WYOMING ESTATES SUBDIVISION GRADING AND EROSION CONTROL PLAN EL PASO COUNTY, CO

EPC STORMWATER REVIEW COMMENTS ARE SHOWN IN ORANGE BOXES WITH BLACK TEXT

| PCD PROJECT NO. MS196 | | | |

| DRAINAGE, GRADING AND EROSION CONTROL PLAN | | |

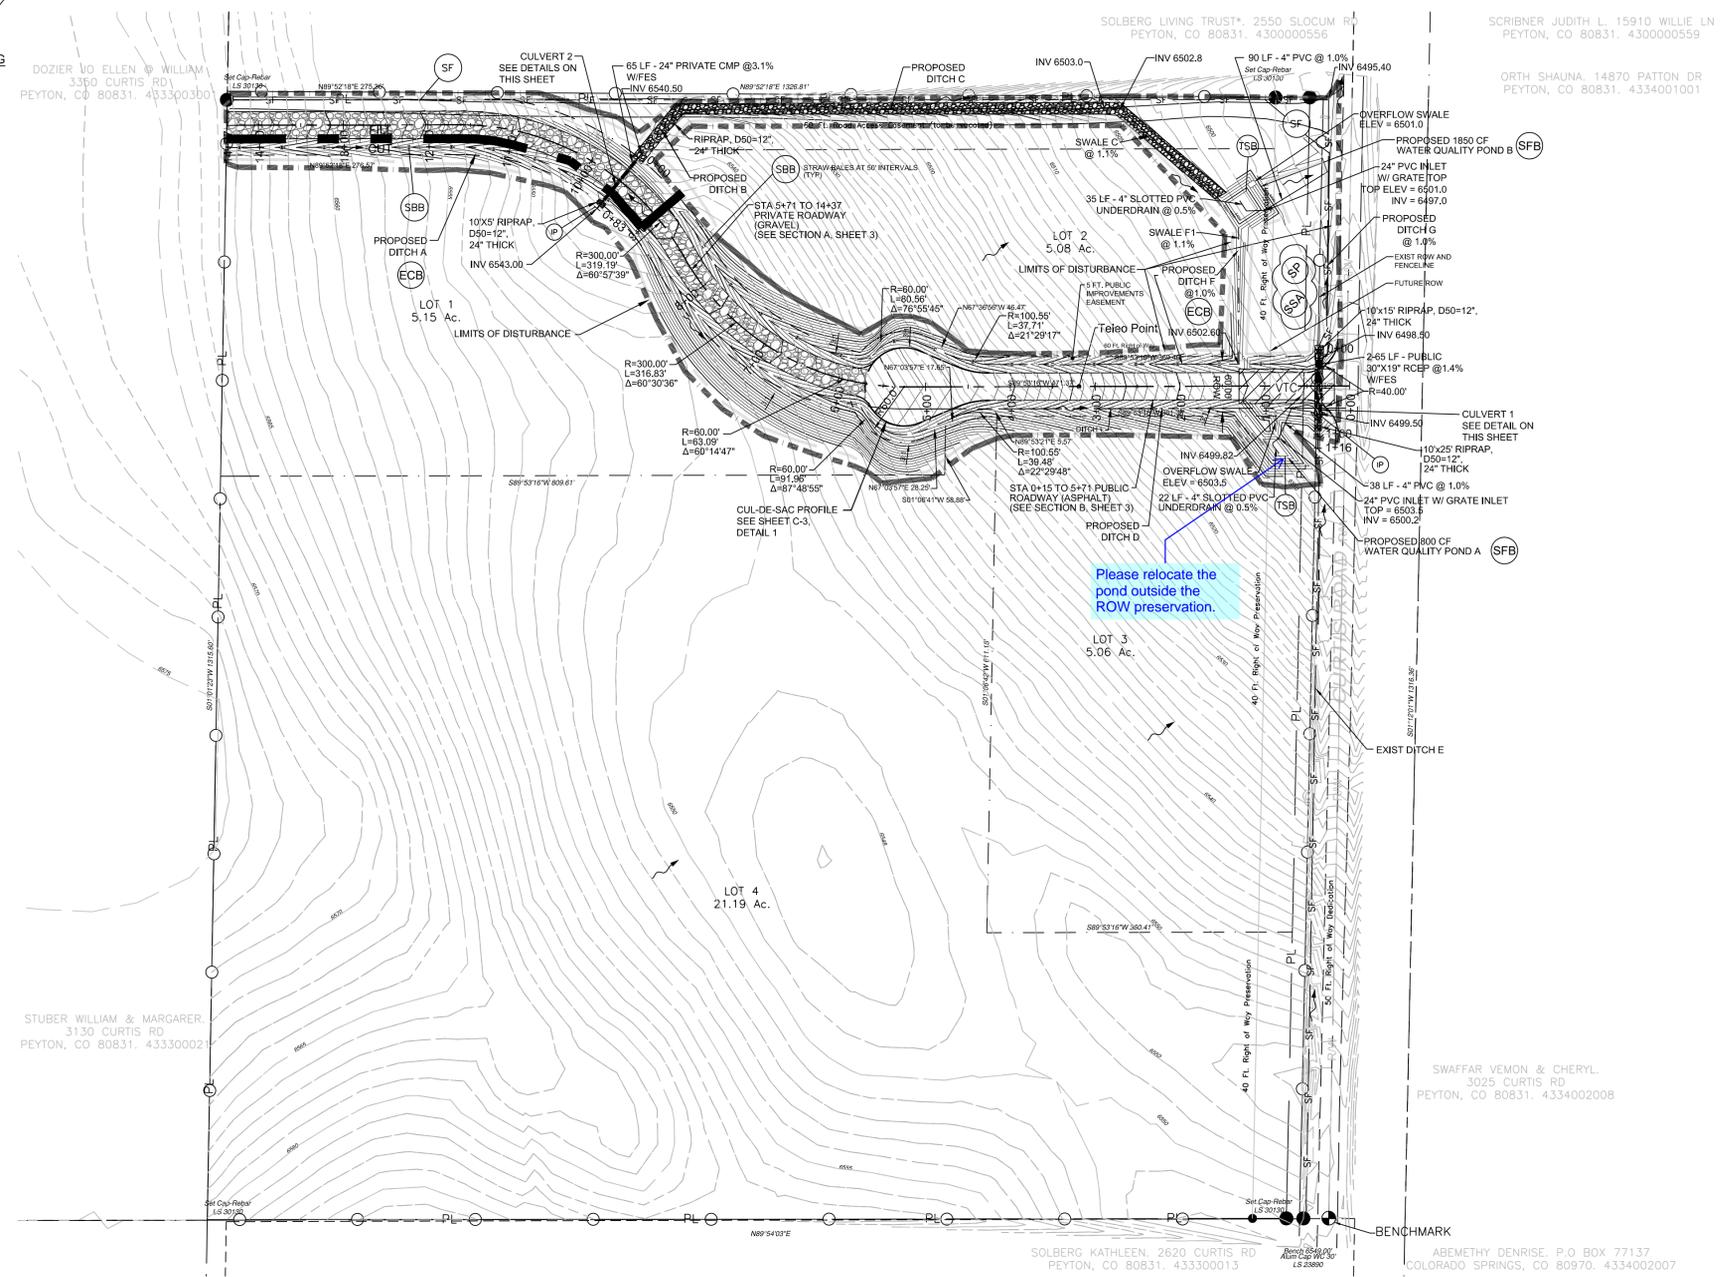
Please relocate the pond outside the ROW preservation.

Show Temporary and Permanent Seeding Locations.
